Site Accessibility Evaluation

**Westside Community Center
423 W Victoria St
Santa Barbara, CA 93101
Accessibility Evaluation
Inspection Date: 08/17/2023
Inspectors: Scott Saddlemire**

**SALLY SWANSON
ARCHITECTS, INC.**

Report Date: 11/03/2023

Finding: 1

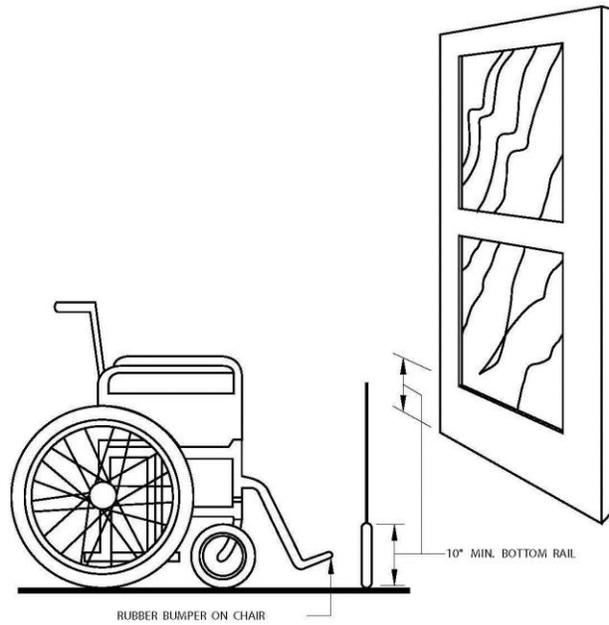
The door has a door stop which prevents it from having a smooth surface at the bottom.

Finding: 2

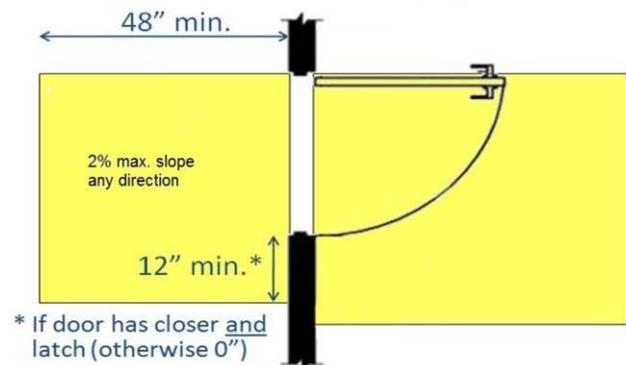
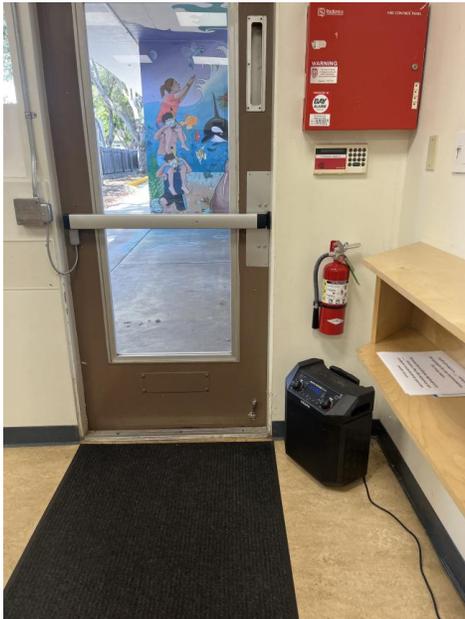
The door is equipped with both a closer and a latch and the latch side clearance is obstructed.

Finding: 3

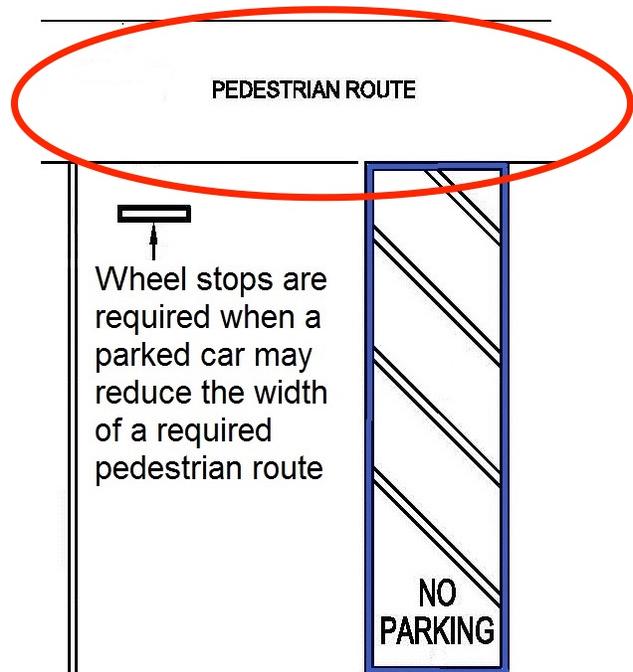
The access aisle is located so that a person with a disability is compelled to travel behind parking spaces other than their own accessible parking space.

Finding: 4

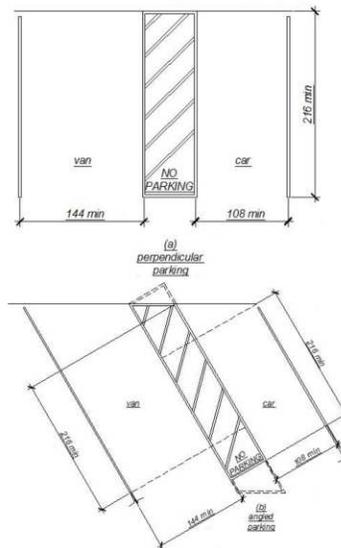
The parking space is in not nearly compliant.

The parking space is not a minimum of 18 feet long. The parking space does not have the proper identifications/fine signs or the signs are not installed at the correct height at proper location. The parking space is missing the ISA markings or the marking is not the required dimensions. The parking space is missing an adjacent access aisle or is designed to have individuals travel behind parking spaces other than their own.

back parking lot

Finding: 5

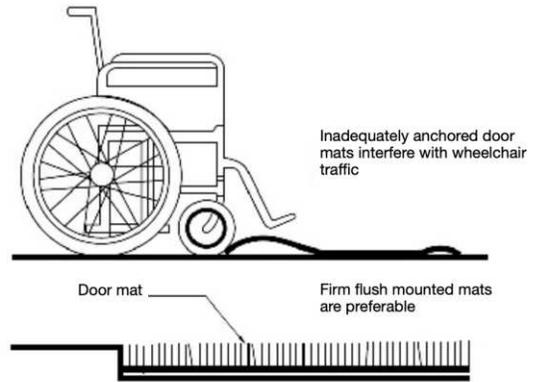
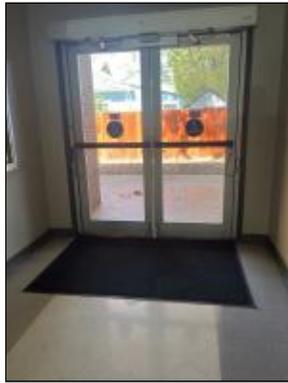
The floor mat at the door is not secured in place.

Finding: 6

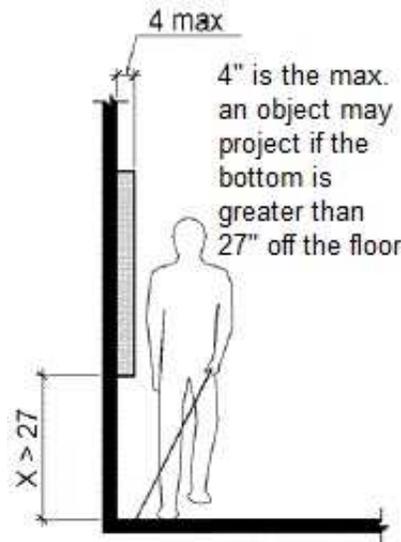
The element projects more than 4 inches into the circulation path.

Finding: 7

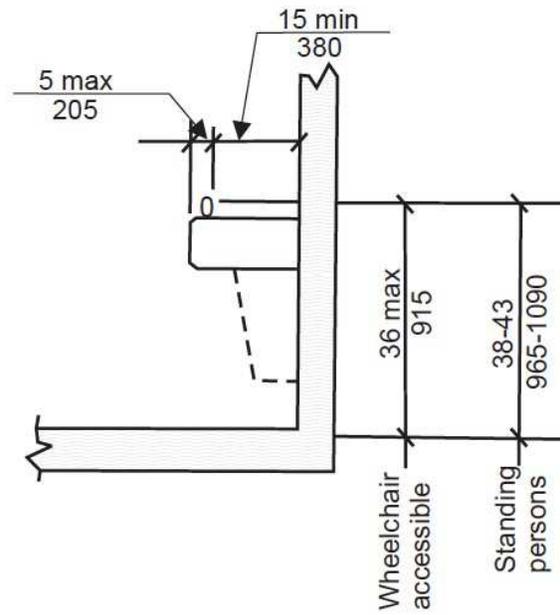
There is no drinking fountain for standing persons.

Finding: 8

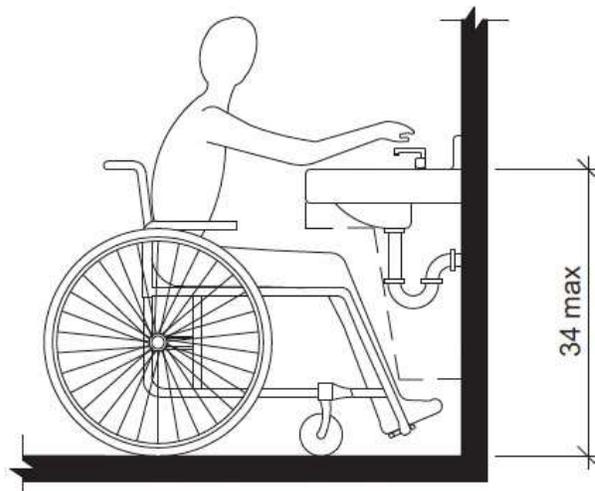
The top rim of the lavatory is too high.

Finding: 9

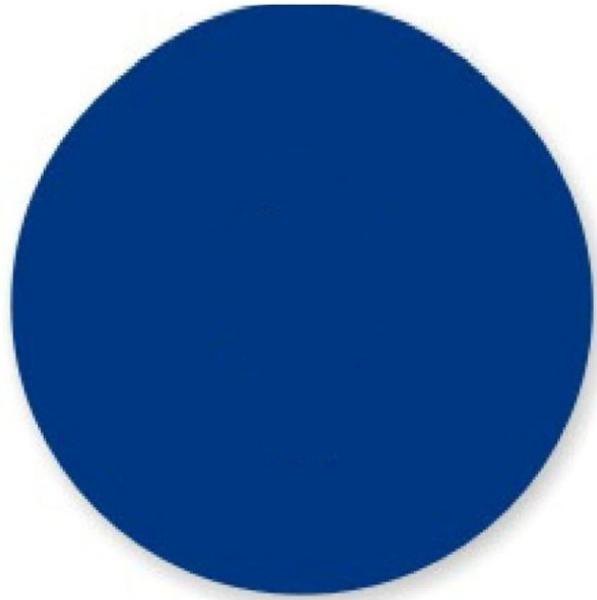
The geometric symbol for the women's room does not contrast with the background.

dark on dark

Finding: 10

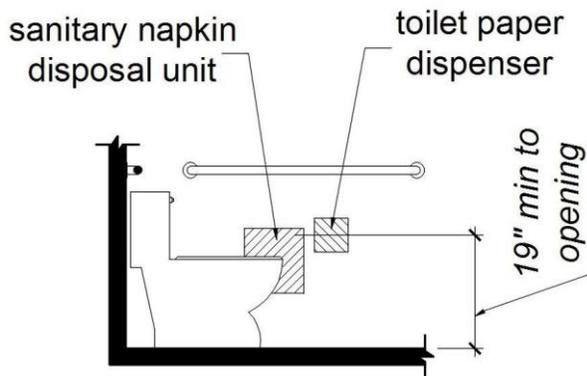
The sanitary napkin disposal units opening is not located correctly between the rear wall and the toilet paper dispenser.

wrong side of paper towel
dispenser

Install on compliant location

Finding: 12

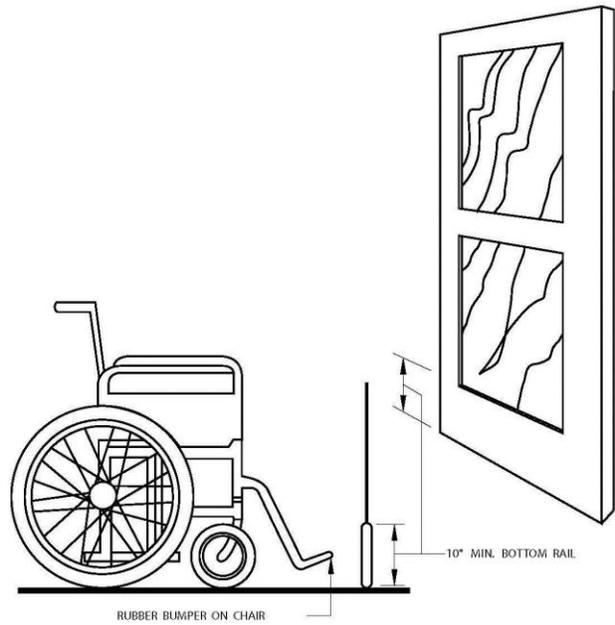
The door has a door stop which prevents it from having a smooth surface at the bottom.

Finding: 13

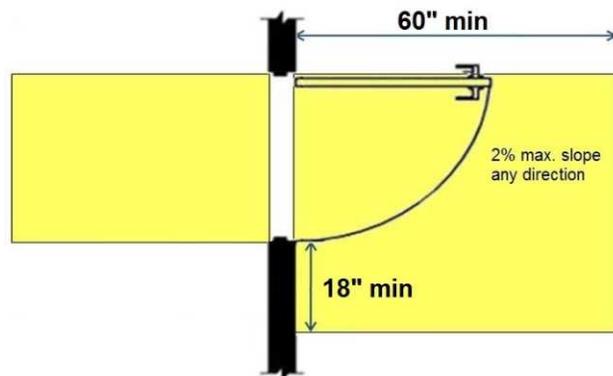
The maneuvering clearance on the pull side of the door extends less than 18 inches beyond the latch side of the door.

Finding: 14

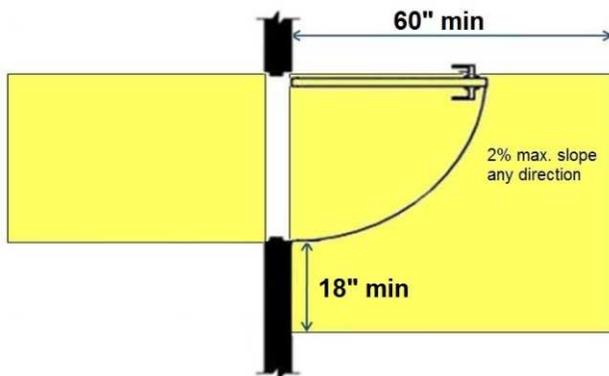
The maneuvering clearance on the pull side of the door extends less than 18 inches beyond the latch side of the door.

Finding: 15

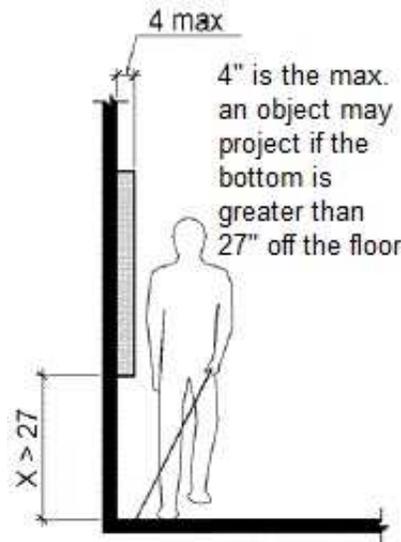
The element projects more than 4 inches into the circulation path.

Finding: 18

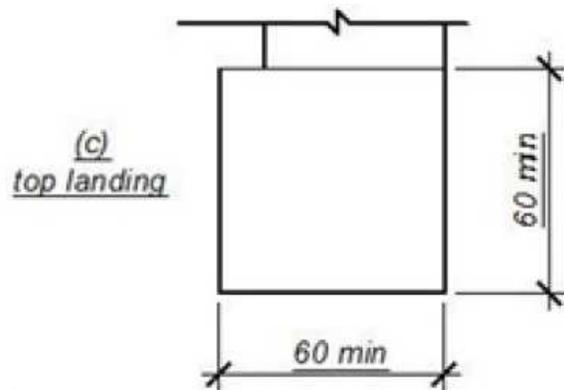
The top landing of the ramp does not meet minimum size requirements.

Citation:	As Built:
2022 CBC 11B Section: 11B-405.7.2.1	not 60" top landing

Finding: 19

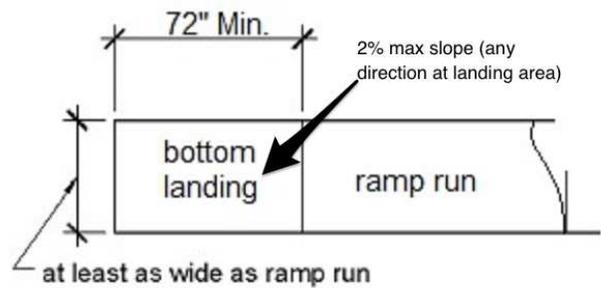
The landing at the bottom of the ramp has a slope greater than 2%.

slope and length

Slope and length not compliant

Finding: 20

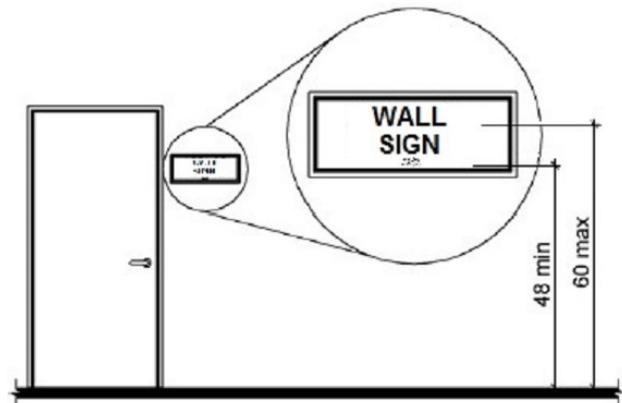
A compliant room identification sign is missing on the strike side of the door.

Finding: 21

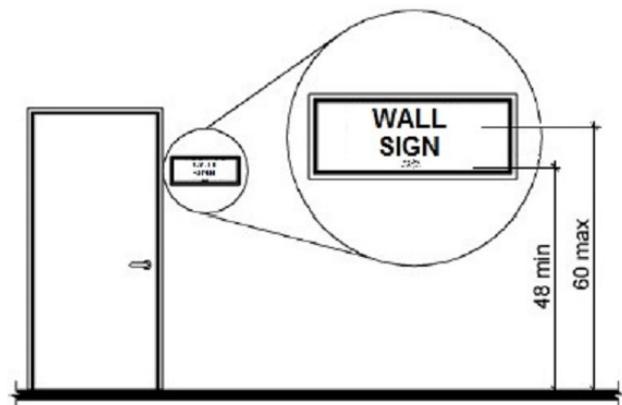
A compliant room identification sign is missing on the strike side of the door.

no compliant wall sign

install a compliant room ID sign at the strike side of the door

Finding: 22

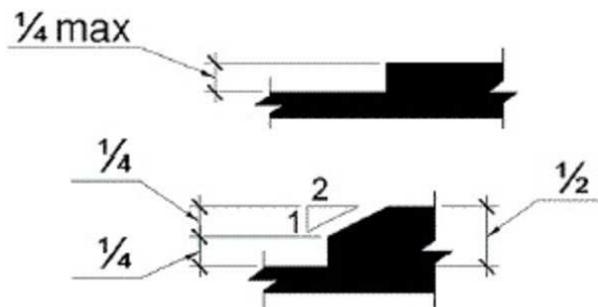
The threshold has a vertical change greater than 1/4 inch.

install a compliant threshold

Finding: 23

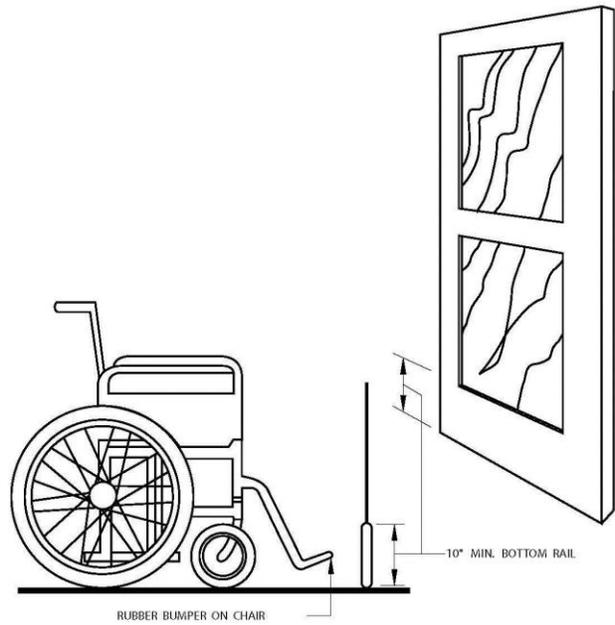
The door has a door stop which prevents it from having a smooth surface at the bottom.

remove door hold open

Finding: 24

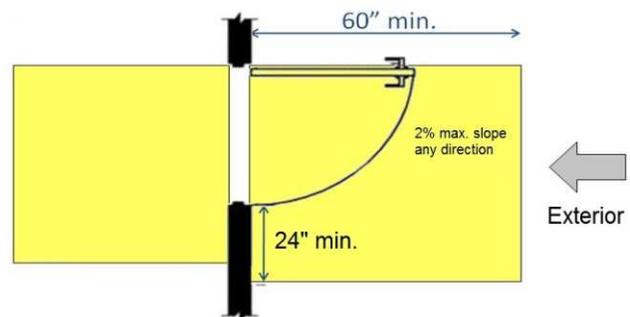
The maneuvering clearance on the pull side of the door is obstructed.

Finding: 26

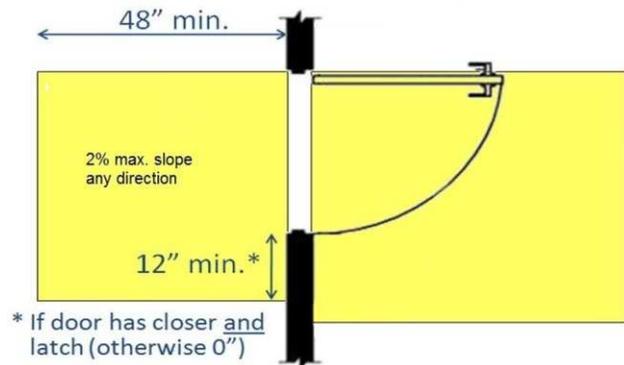
The door is equipped with both a closer and a latch and the latch side clearance is obstructed.

not a Constuction related item, but should be part of your ADA program

Finding: 27

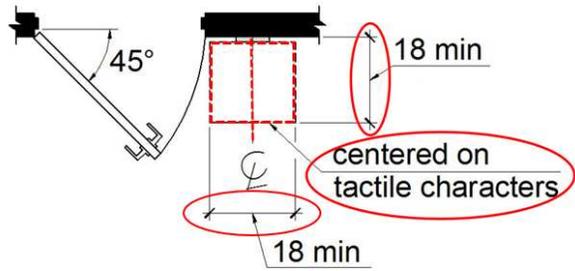
A clear floor space is not provided in front of the sign.

Typical throughout

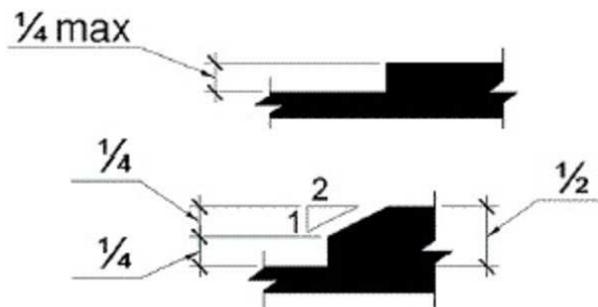
The threshold has a vertical change greater than 1/4 inch.

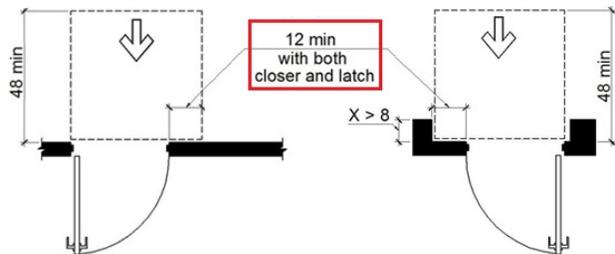
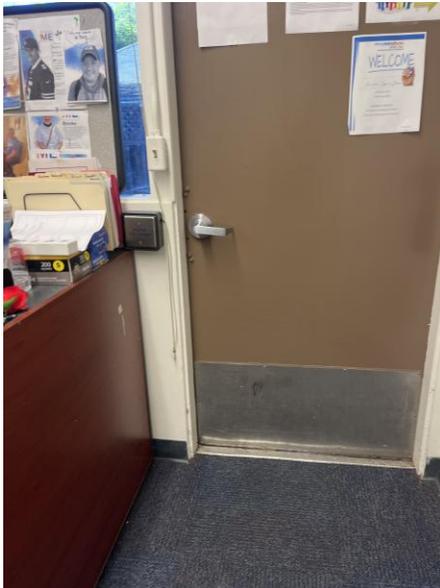
Maneuvering clearance for doors on the push side equipped with both a closer and latch must be 48 inches minimum in depth. The width of the maneuvering clearance must be as wide as the door plus an additional 12 inches on the latch side. Doors recessed on the latch side greater than 8 inches must provide the additional 12 inches of clearance within the recess. The maneuvering clearance must be flat (2% max. slope in any direction) and clear of obstructions.

push button did not work

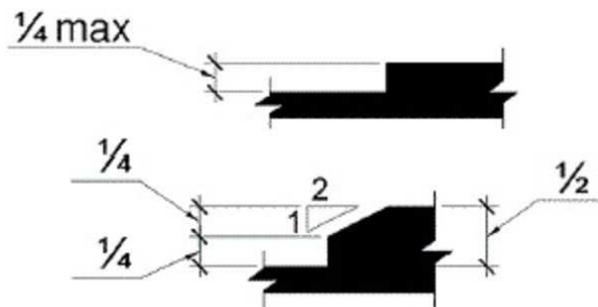
The threshold has a vertical change greater than 1/4 inch.
